**SUBDIVISION,
PLANNED UNIT DEVELOPMENT
& ZONING AMENDMENT STAFF REPORT****Date: March 15, 2018****APPLICANT NAME**

D.R. Horton, Inc. - Birmingham

Longleaf Gates Subdivision, Phase Two

LOCATION6050 Whitebark Drive
(North side of Girby Road, 125'± East of Bristlecone Drive, extending to the East terminus of Whitebark Drive).**CITY COUNCIL
DISTRICT**

SITE PLAN

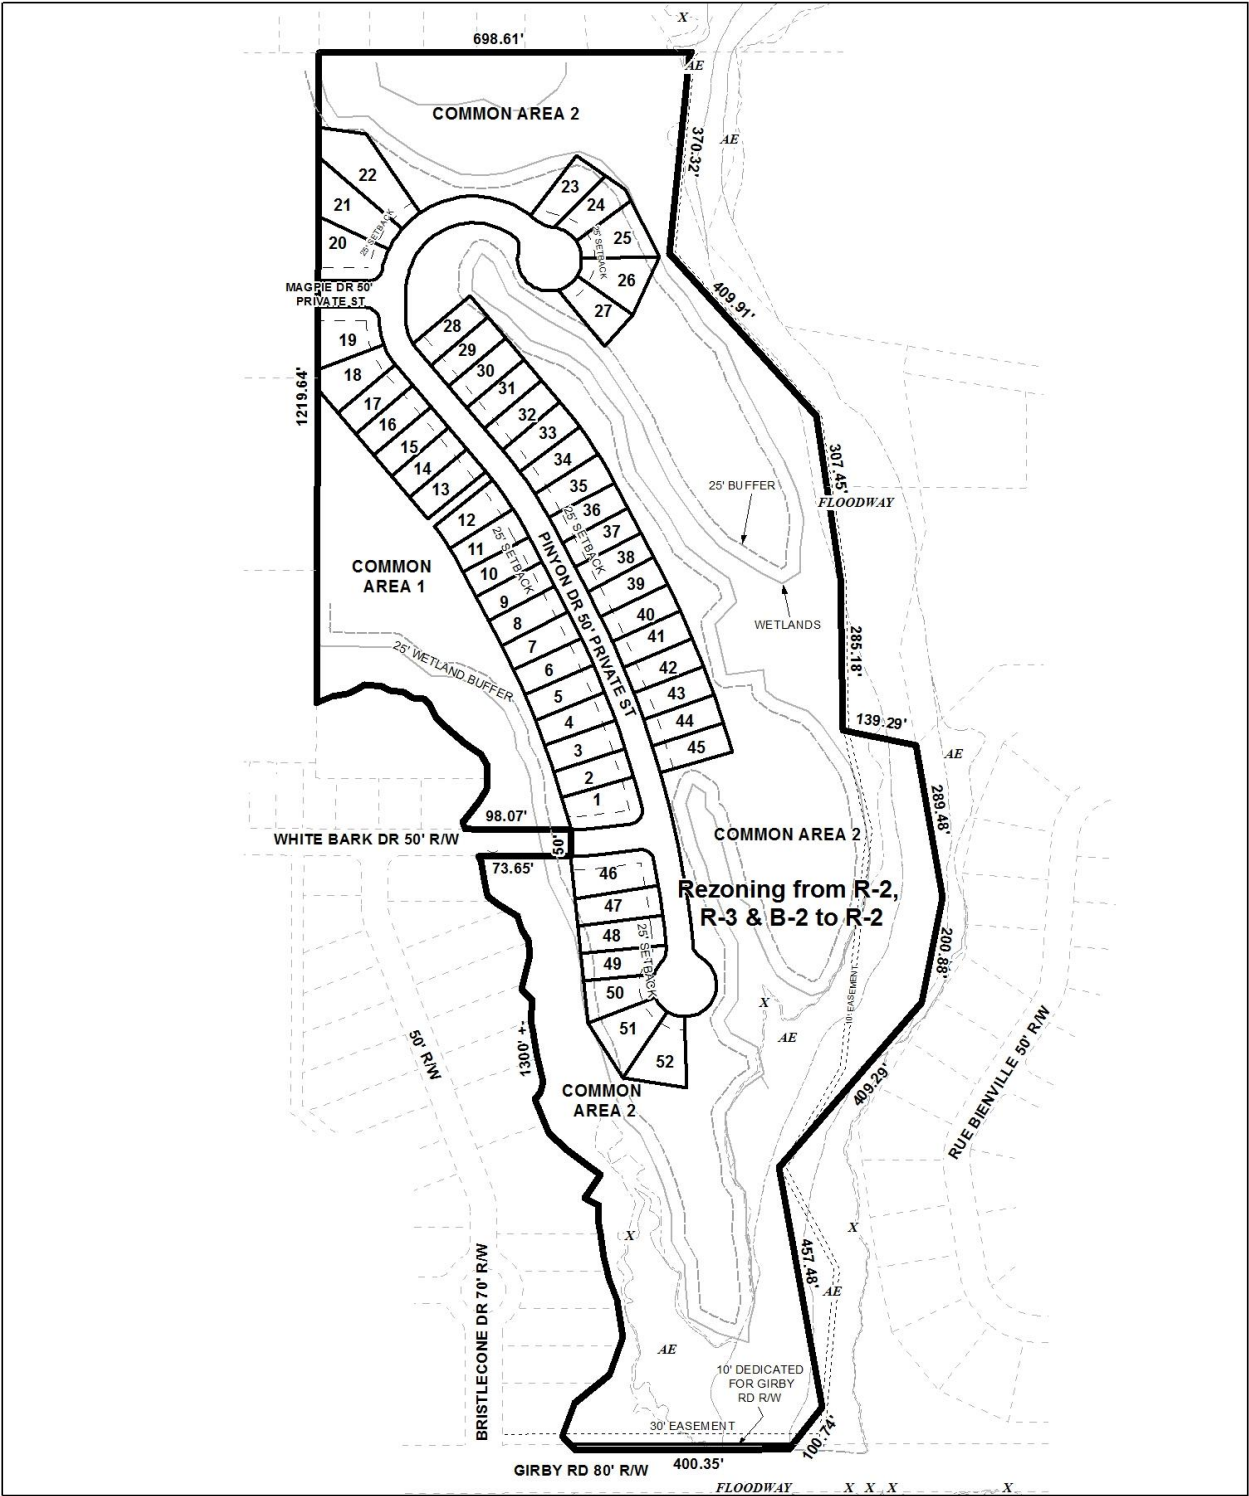
The proposed private street is provided with cul-de-sacs at both terminuses in compliance with Section VIII.E.1.a. of the Subdivision Regulations; however, they do not appear to comply with Section V.B.14. regarding the required 120' turnaround right-of-way diameter. The plat and site plan should be revised to illustrate compliant turnaround rights-of-way for both proposed cul-de-sacs, if approved.

The proposed lots meet the minimum area requirements for lots served by public water and sanitary sewer systems; however, while lot sizes are provided in square feet on the preliminary plat and site plan, they are not provided in acres. As such, revision of the plat and site plan to depict the sizes of each lot in both square feet and acres should be required, adjusted for any dedication; or, provision of a table on the Final Plat and PUD site plan providing the same information may suffice.

It should be pointed out that while each lot will meet the minimum area requirements, many of the proposed lots will be less than 60 feet in width at the minimum building setback line. The reduced lot width would be in keeping with the earlier phase of the development, which had numerous lots only 50 feet in width. Thus a waiver of Section V.D.2. of the Subdivision Regulations, regarding the minimum lot width, will be required.

Two common areas are provided on the preliminary plat and site plan, to include a detention area between proposed Lots 27 and 28, and are labeled with their sizes in acres. The plat and site plan should be revised to also provide their sizes in square feet, adjusted for any dedication; or, provision of a table on the Final Plat and PUD site plan providing the same information may suffice. A note should also be provided on the Final Plat and PUD site plan stating that the

The 25' minimum building setback line is not illustrated along Girby Road or along the frontages of either common area, but it is illustrated along the frontages of all proposed lots and a note on the plat and site plan iterates this requirement; however, the line itself is not labeled. As such, revision of the plat and site plan to illustrate the 25' minimum building setback line along Girby Road and label the 25' minimum building setback line along the remaining lots and common areas should be required, if approved, adjusted for any dedication.

Multiple easements are illustrated on the plat and site plan, including a 10' sanitary sewer easement along the East property line and a 30' sewer easement along Girby Road. A note stating a 10' drainage and utility easement is dedicated along the frontage of all proposed lots and along lot lines abutting a right-of-way is also provided. As such, if approved, an additional note should be required on the Final Plat and PUD site plan stating no structures shall be constructed in any easement.

- 1) revision of the PUD site plan to illustrate 120' turnaround right-of-way diameters compliant with Section V.B.14. of the Subdivision Regulations at each terminus of the proposed Pinyon Drive;

- 2) revision of the PUD site plan to illustrate the sizes of all lots and common areas in both square feet and acres, or the provision of a table on the PUD site plan providing the same information, adjusted for any dedication;

- 3) placement of a note on the PUD site plan stating that the maintenance of all common areas is the responsibility of the property owners;
- 4) revision of the PUD site plan to illustrate and label the 25' minimum building setback line along street frontages of all lots and common areas;
